Re: 25 Martin Road Badgerys Creek - Response to JRPP Vibration Request

Wilkinson Murray conducted a Noise Impact Assessment (NIA) for the proposed Resource Recovery Facility at 25 Martin Road, Badgerys Creek (Wilkinson Murray Report No. 13351 Version B).

Figure 1 Offset Distance to Nearest Identified Receivers

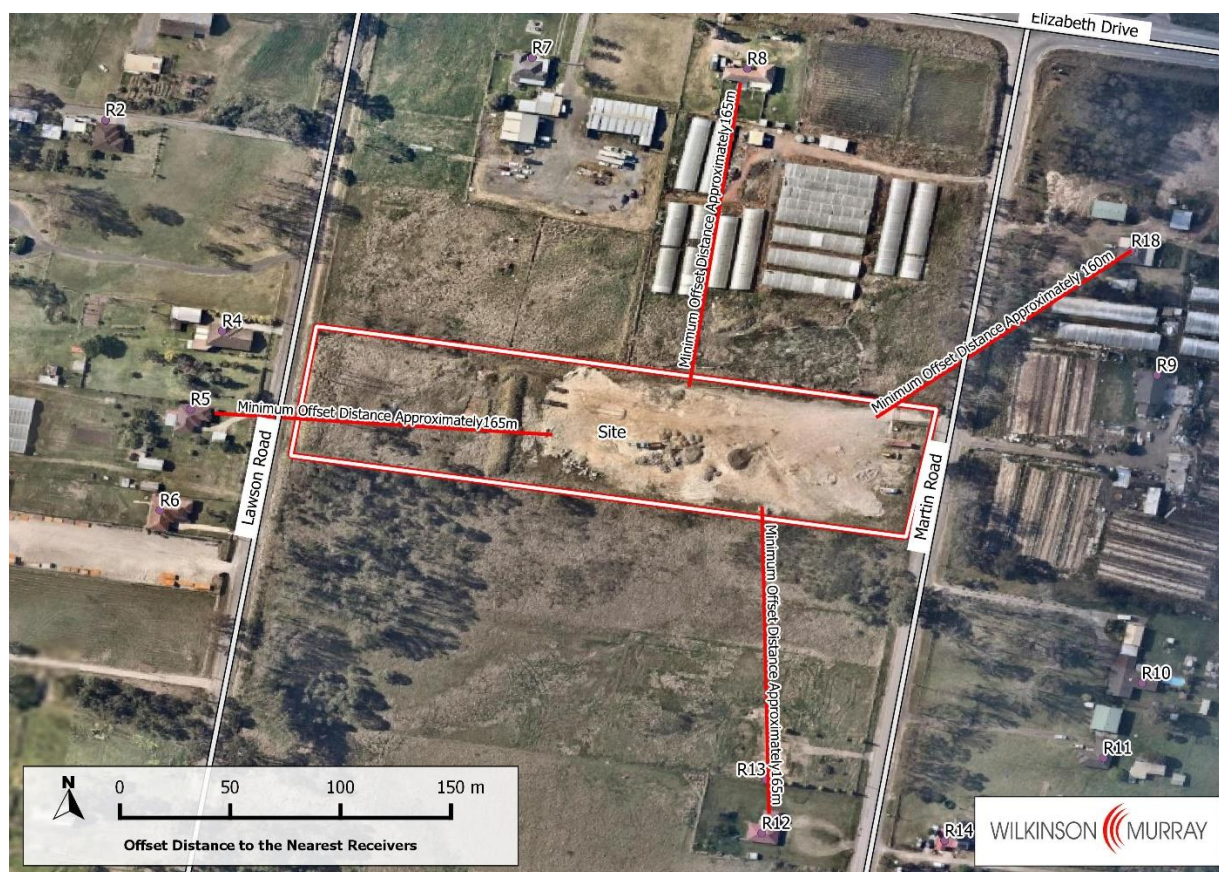
"the Panel requires confirmation that there would be no unacceptable amenity impacts upon local residual properties in the vicinity from vibration."

Figure 1 shows the relative location of the nearest residential receivers to the site, along with the relative offset distance to any equipment possibly operating on site.

The presented distance is a worst case placement of equipment within the site, with the actual offset distance are expected to be greater.

The worst case offset distances are as follows:

- Approximately 165m to R4 / R5 / R6 located to the west of the site;
- Approximately 165m to R8 located to the north of the site;
- Approximately 160m to R18 to the east of the site; and
- Approximately 165m to R12 to the south of the site.

Specifically, the measured vibration level of 0.06mm/s PPV at an offset distance of 165m indicates that the vibration emission from the site would not be perceivable at any of the nearest residential receivers.
